**ADDENDUM
NO. 3**

November 6, 2023

**HANOVER COMMUNITY SCHOOLS - JANE BALL ELEMENTARY
RENOVATIONS AND HIGH SCHOOL IMPROVEMENTS**

Addendum Two (AD.03) to the drawings and specifications prepared by Gibraltar Design for **Hanover CSC – Jane Ball ES Renovation and HS Improvements** for Hanover Community School Corporation, Cedar Lake, Indiana.

GIBRALTAR DESIGN SHEET
JB A-101

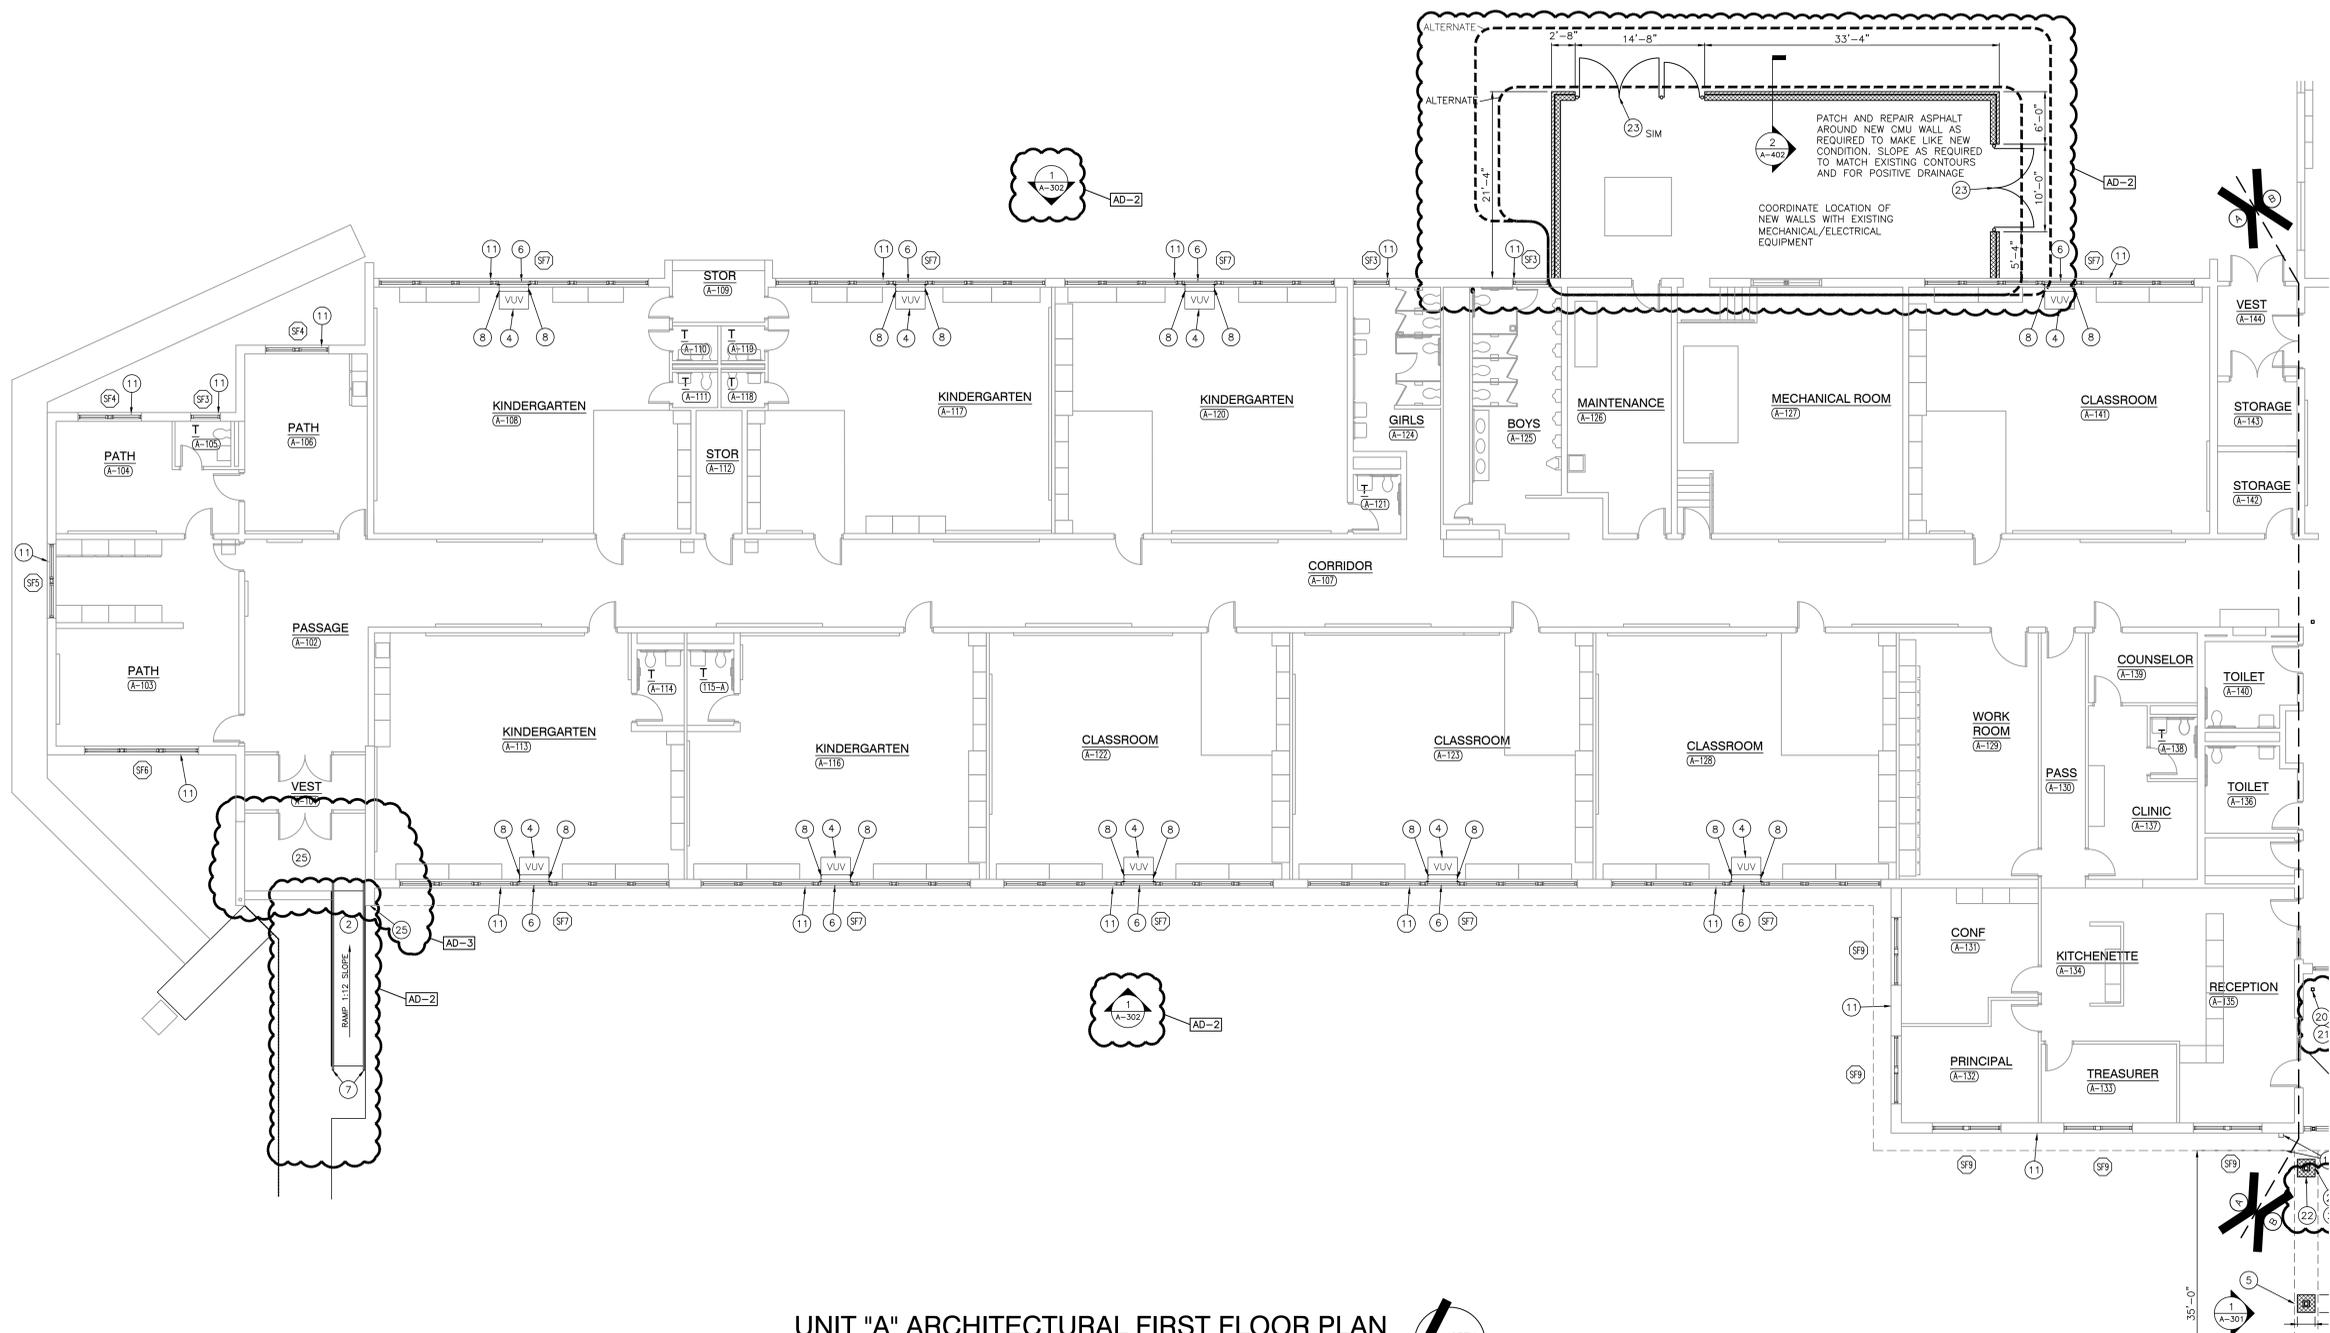
14. Sheet A-101

- A. Refer to revised full-size drawing, included in this Addendum for the following revisions.
 - 1. Add note to epoxy inject cracks in the concrete stoop and foundation at and around the north entrance.
 - 2. Revise note 10 to call out louver size.

SHEET
JB A-102

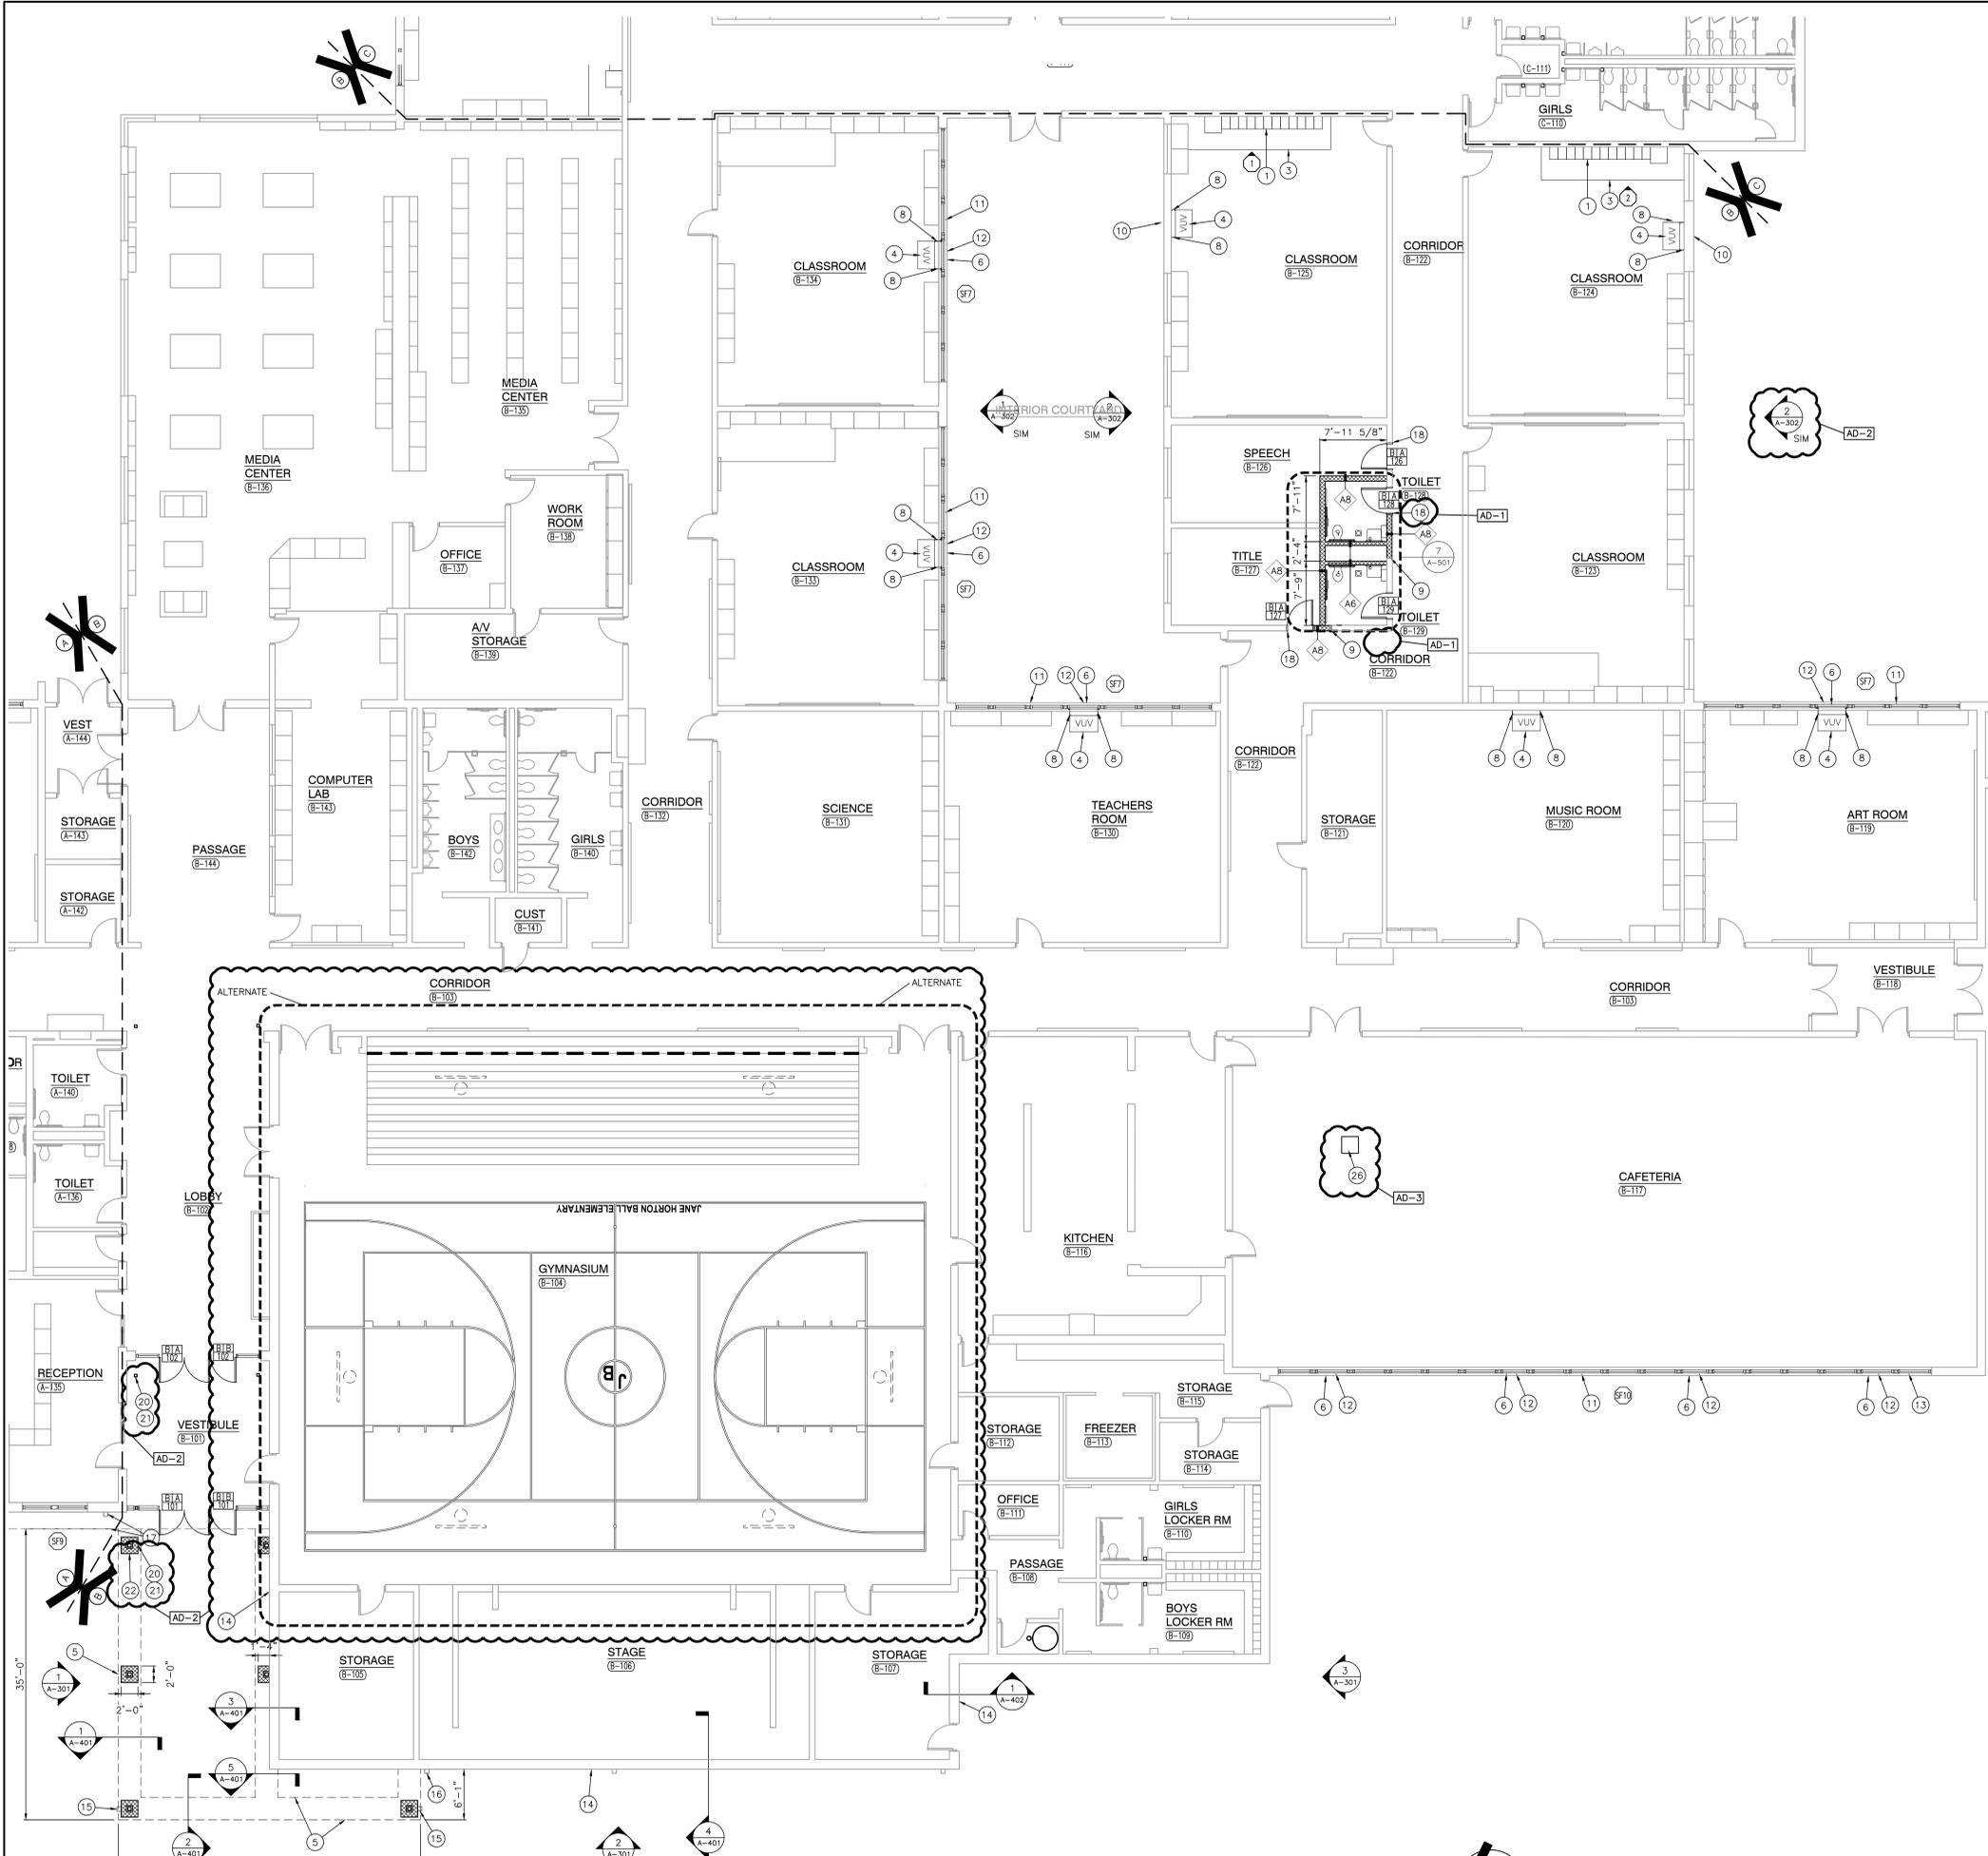
15. Sheet A-102

- A. Refer to revised full-size drawing, included in this Addendum for the following revisions.
 - 1. Add note 25 to epoxy inject cracks in the concrete stoop and foundation at and around the north entrance.

2. Add note 26 to cap existing mechanical opening in ceiling of the cafeteria.

© GIBRALTAR DESIGN SHEET
JB A-103

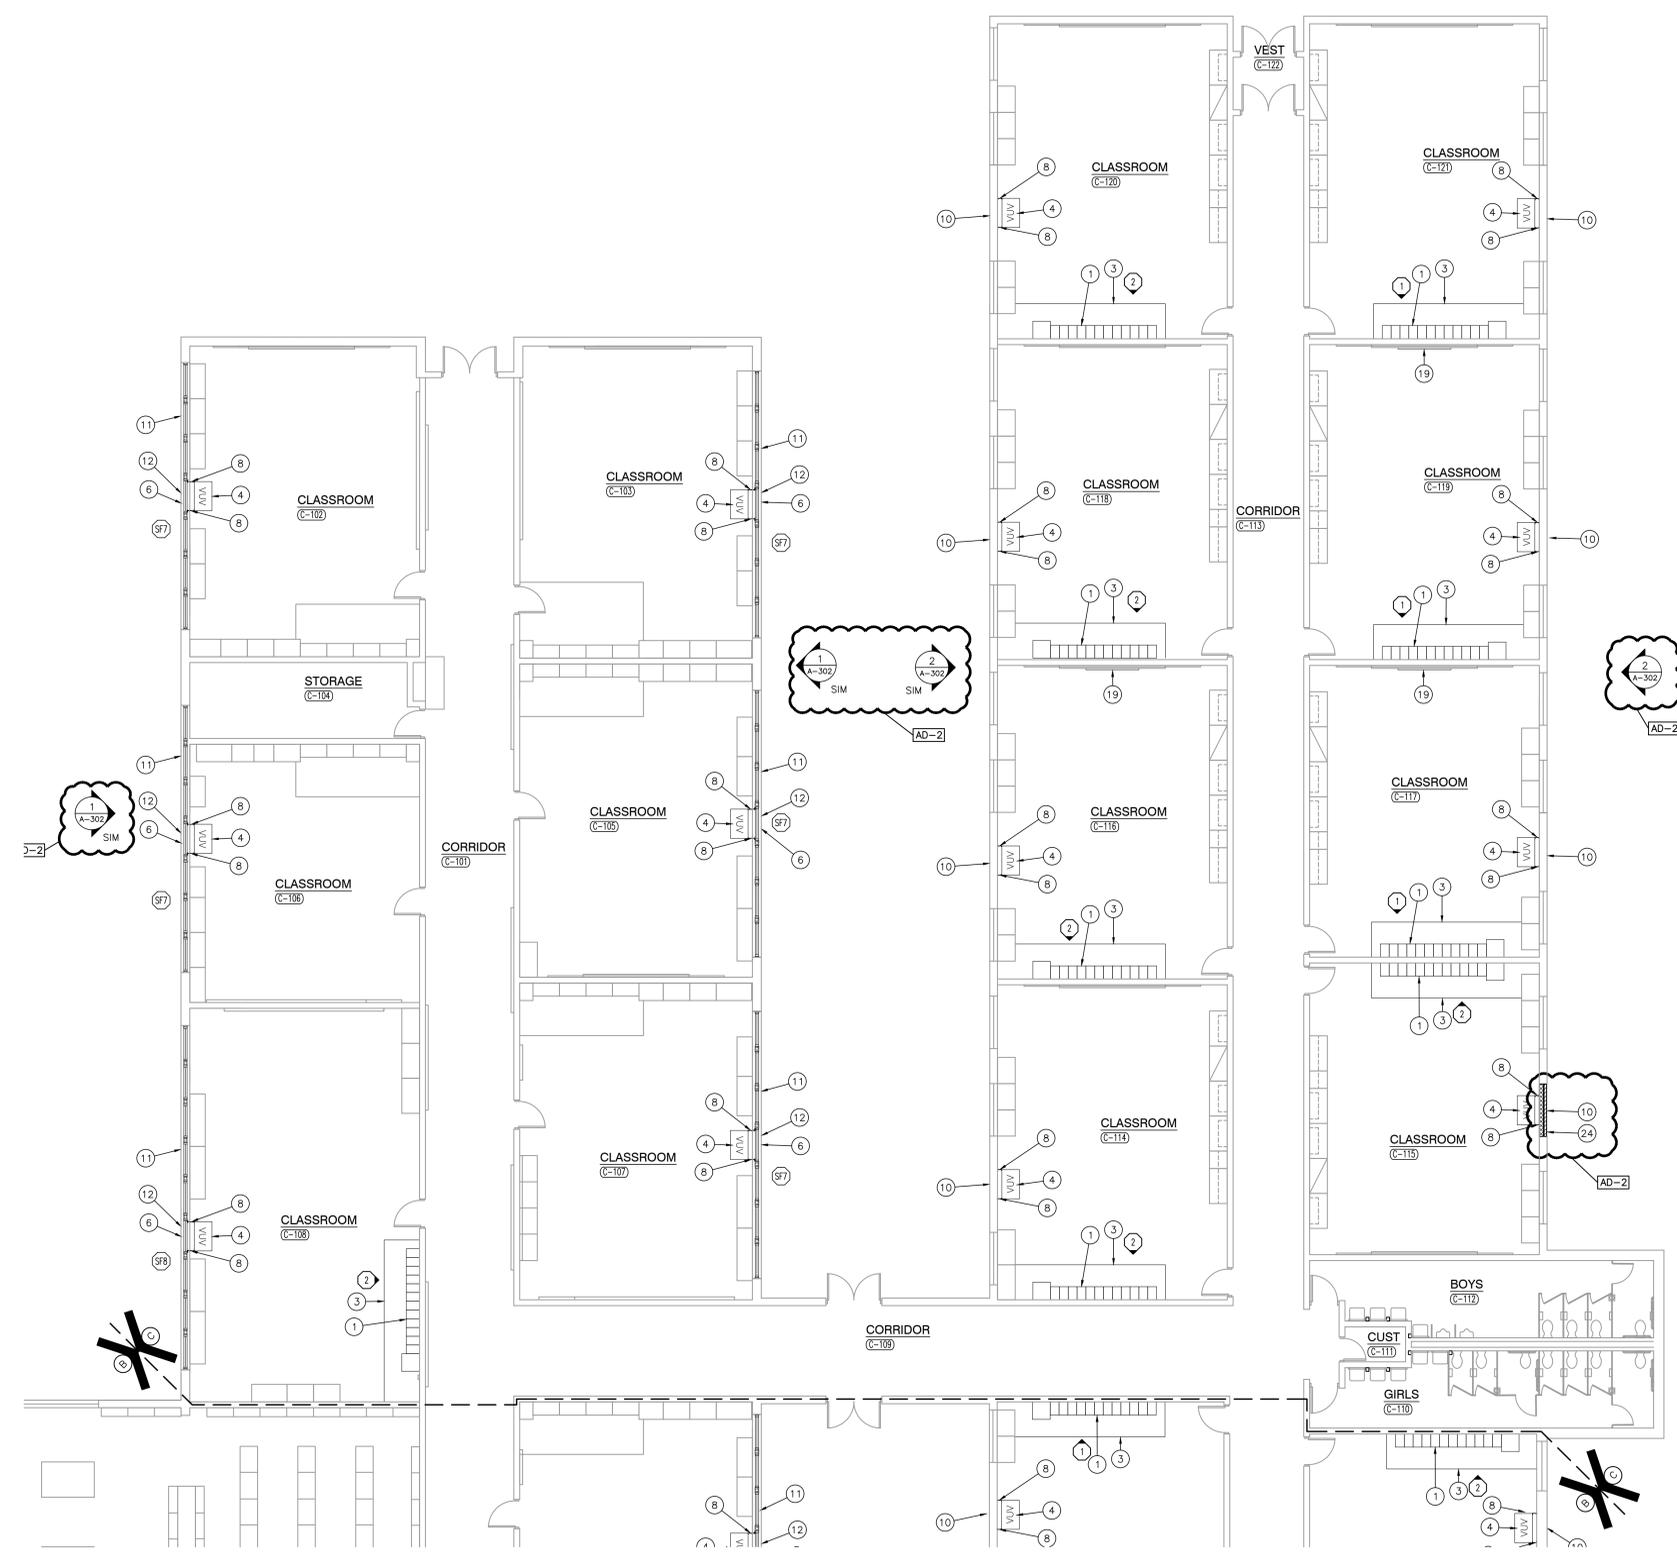
16. Sheet A-103

- A. Refer to revised full-size drawing, included in this Addendum for the revision of note 10 to call out louver size.
